STAFF RECOMMENDATION
934 McFerrin Avenue
March 21, 2018

Application: Demolition—primary structure; New construction-infill
District: Greenwood Neighborhood Conservation Zoning Overlay
Council District: 05
Map and Parcel Number: 08208010200
Applicant: Root Arch
Project Lead: Melissa Baldock, melissa.baldock@nashville.gov

Description of Project: Application is to demolish a non-contributing house and to construct a development with six structures and twelve residential units. **Recommendation Summary:** Staff recommends approval of the demolition of the existing structure on the lot, finding that its demolition meets Section III.B.2. of the design guidelines. Staff recommends disapproval of the new construction, finding that the proposed development does not meet Sections II.B.1.a (Height), II.B.1.b. (Scale), II.B.1.c. (Setback & Rhythm of Spacing), II.B.1.f (Orientation), II.B.1.g. (Proportion and Rhythm of Openings), and II.B.1.k. (Multi-unit Detached Developments/ Cottage Developments) of the design guidelines for the Greenwood Neighborhood Conservation Zoning Overlay.	**Attachments** **A:** Photographs **B:** Site Plan **C:** Elevations

MCFERRIN AVENUE (UNIT 7) & EAST ELEVATION (UNITS 9 & 11)

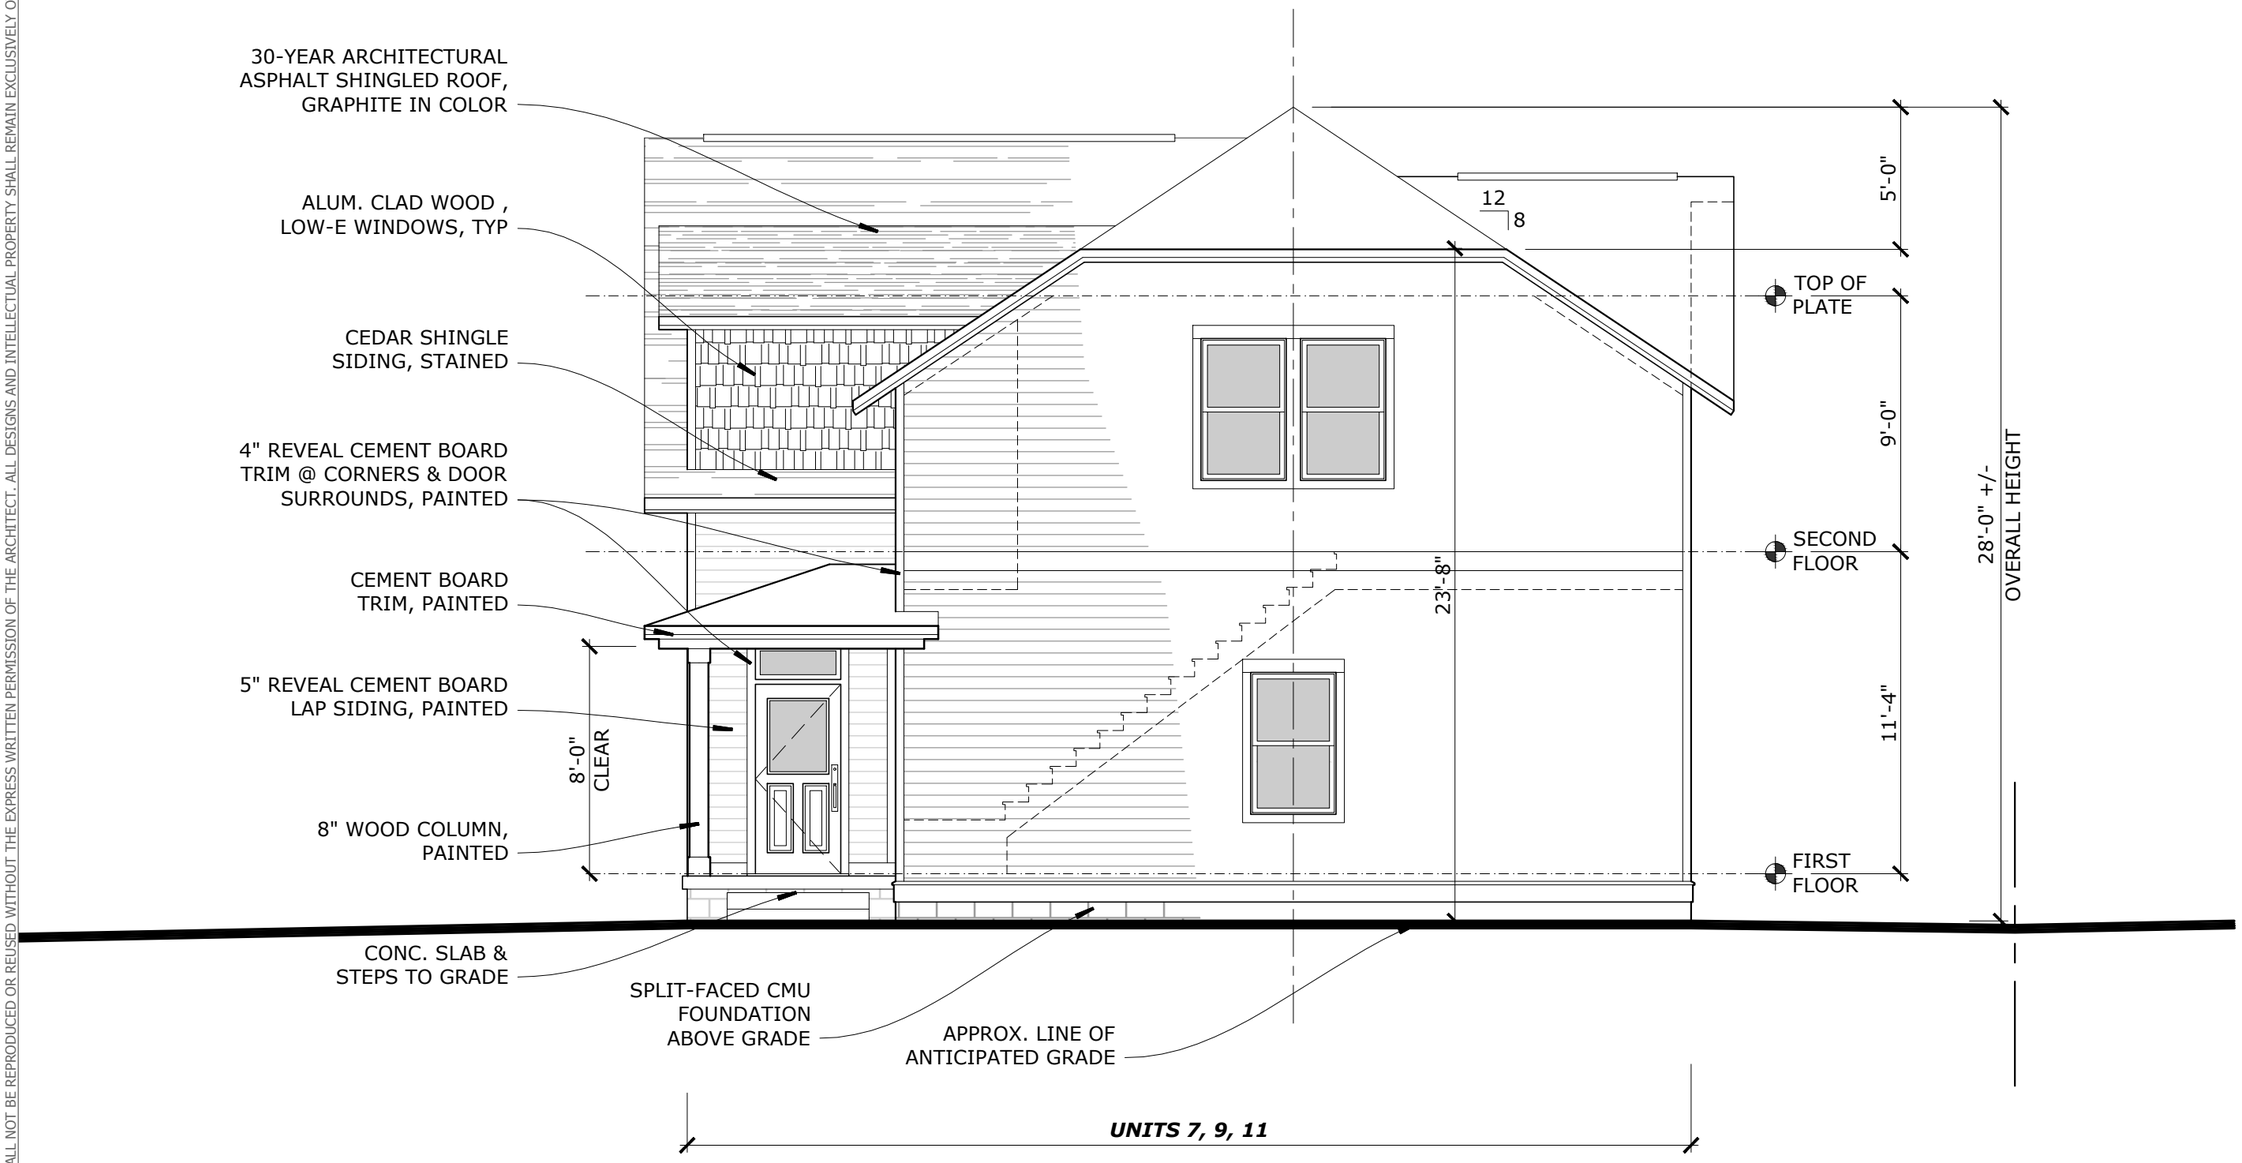
At the rear of the lot, a new walkway will be added, providing access to the rear units. Of the rear units, only Unit 7 will have street frontage. For that unit, the entrance will face McFerrin Avenue, and there will be a walkway leading from the McFerrin sidewalk to the entrance. Staff finds this to be appropriate.
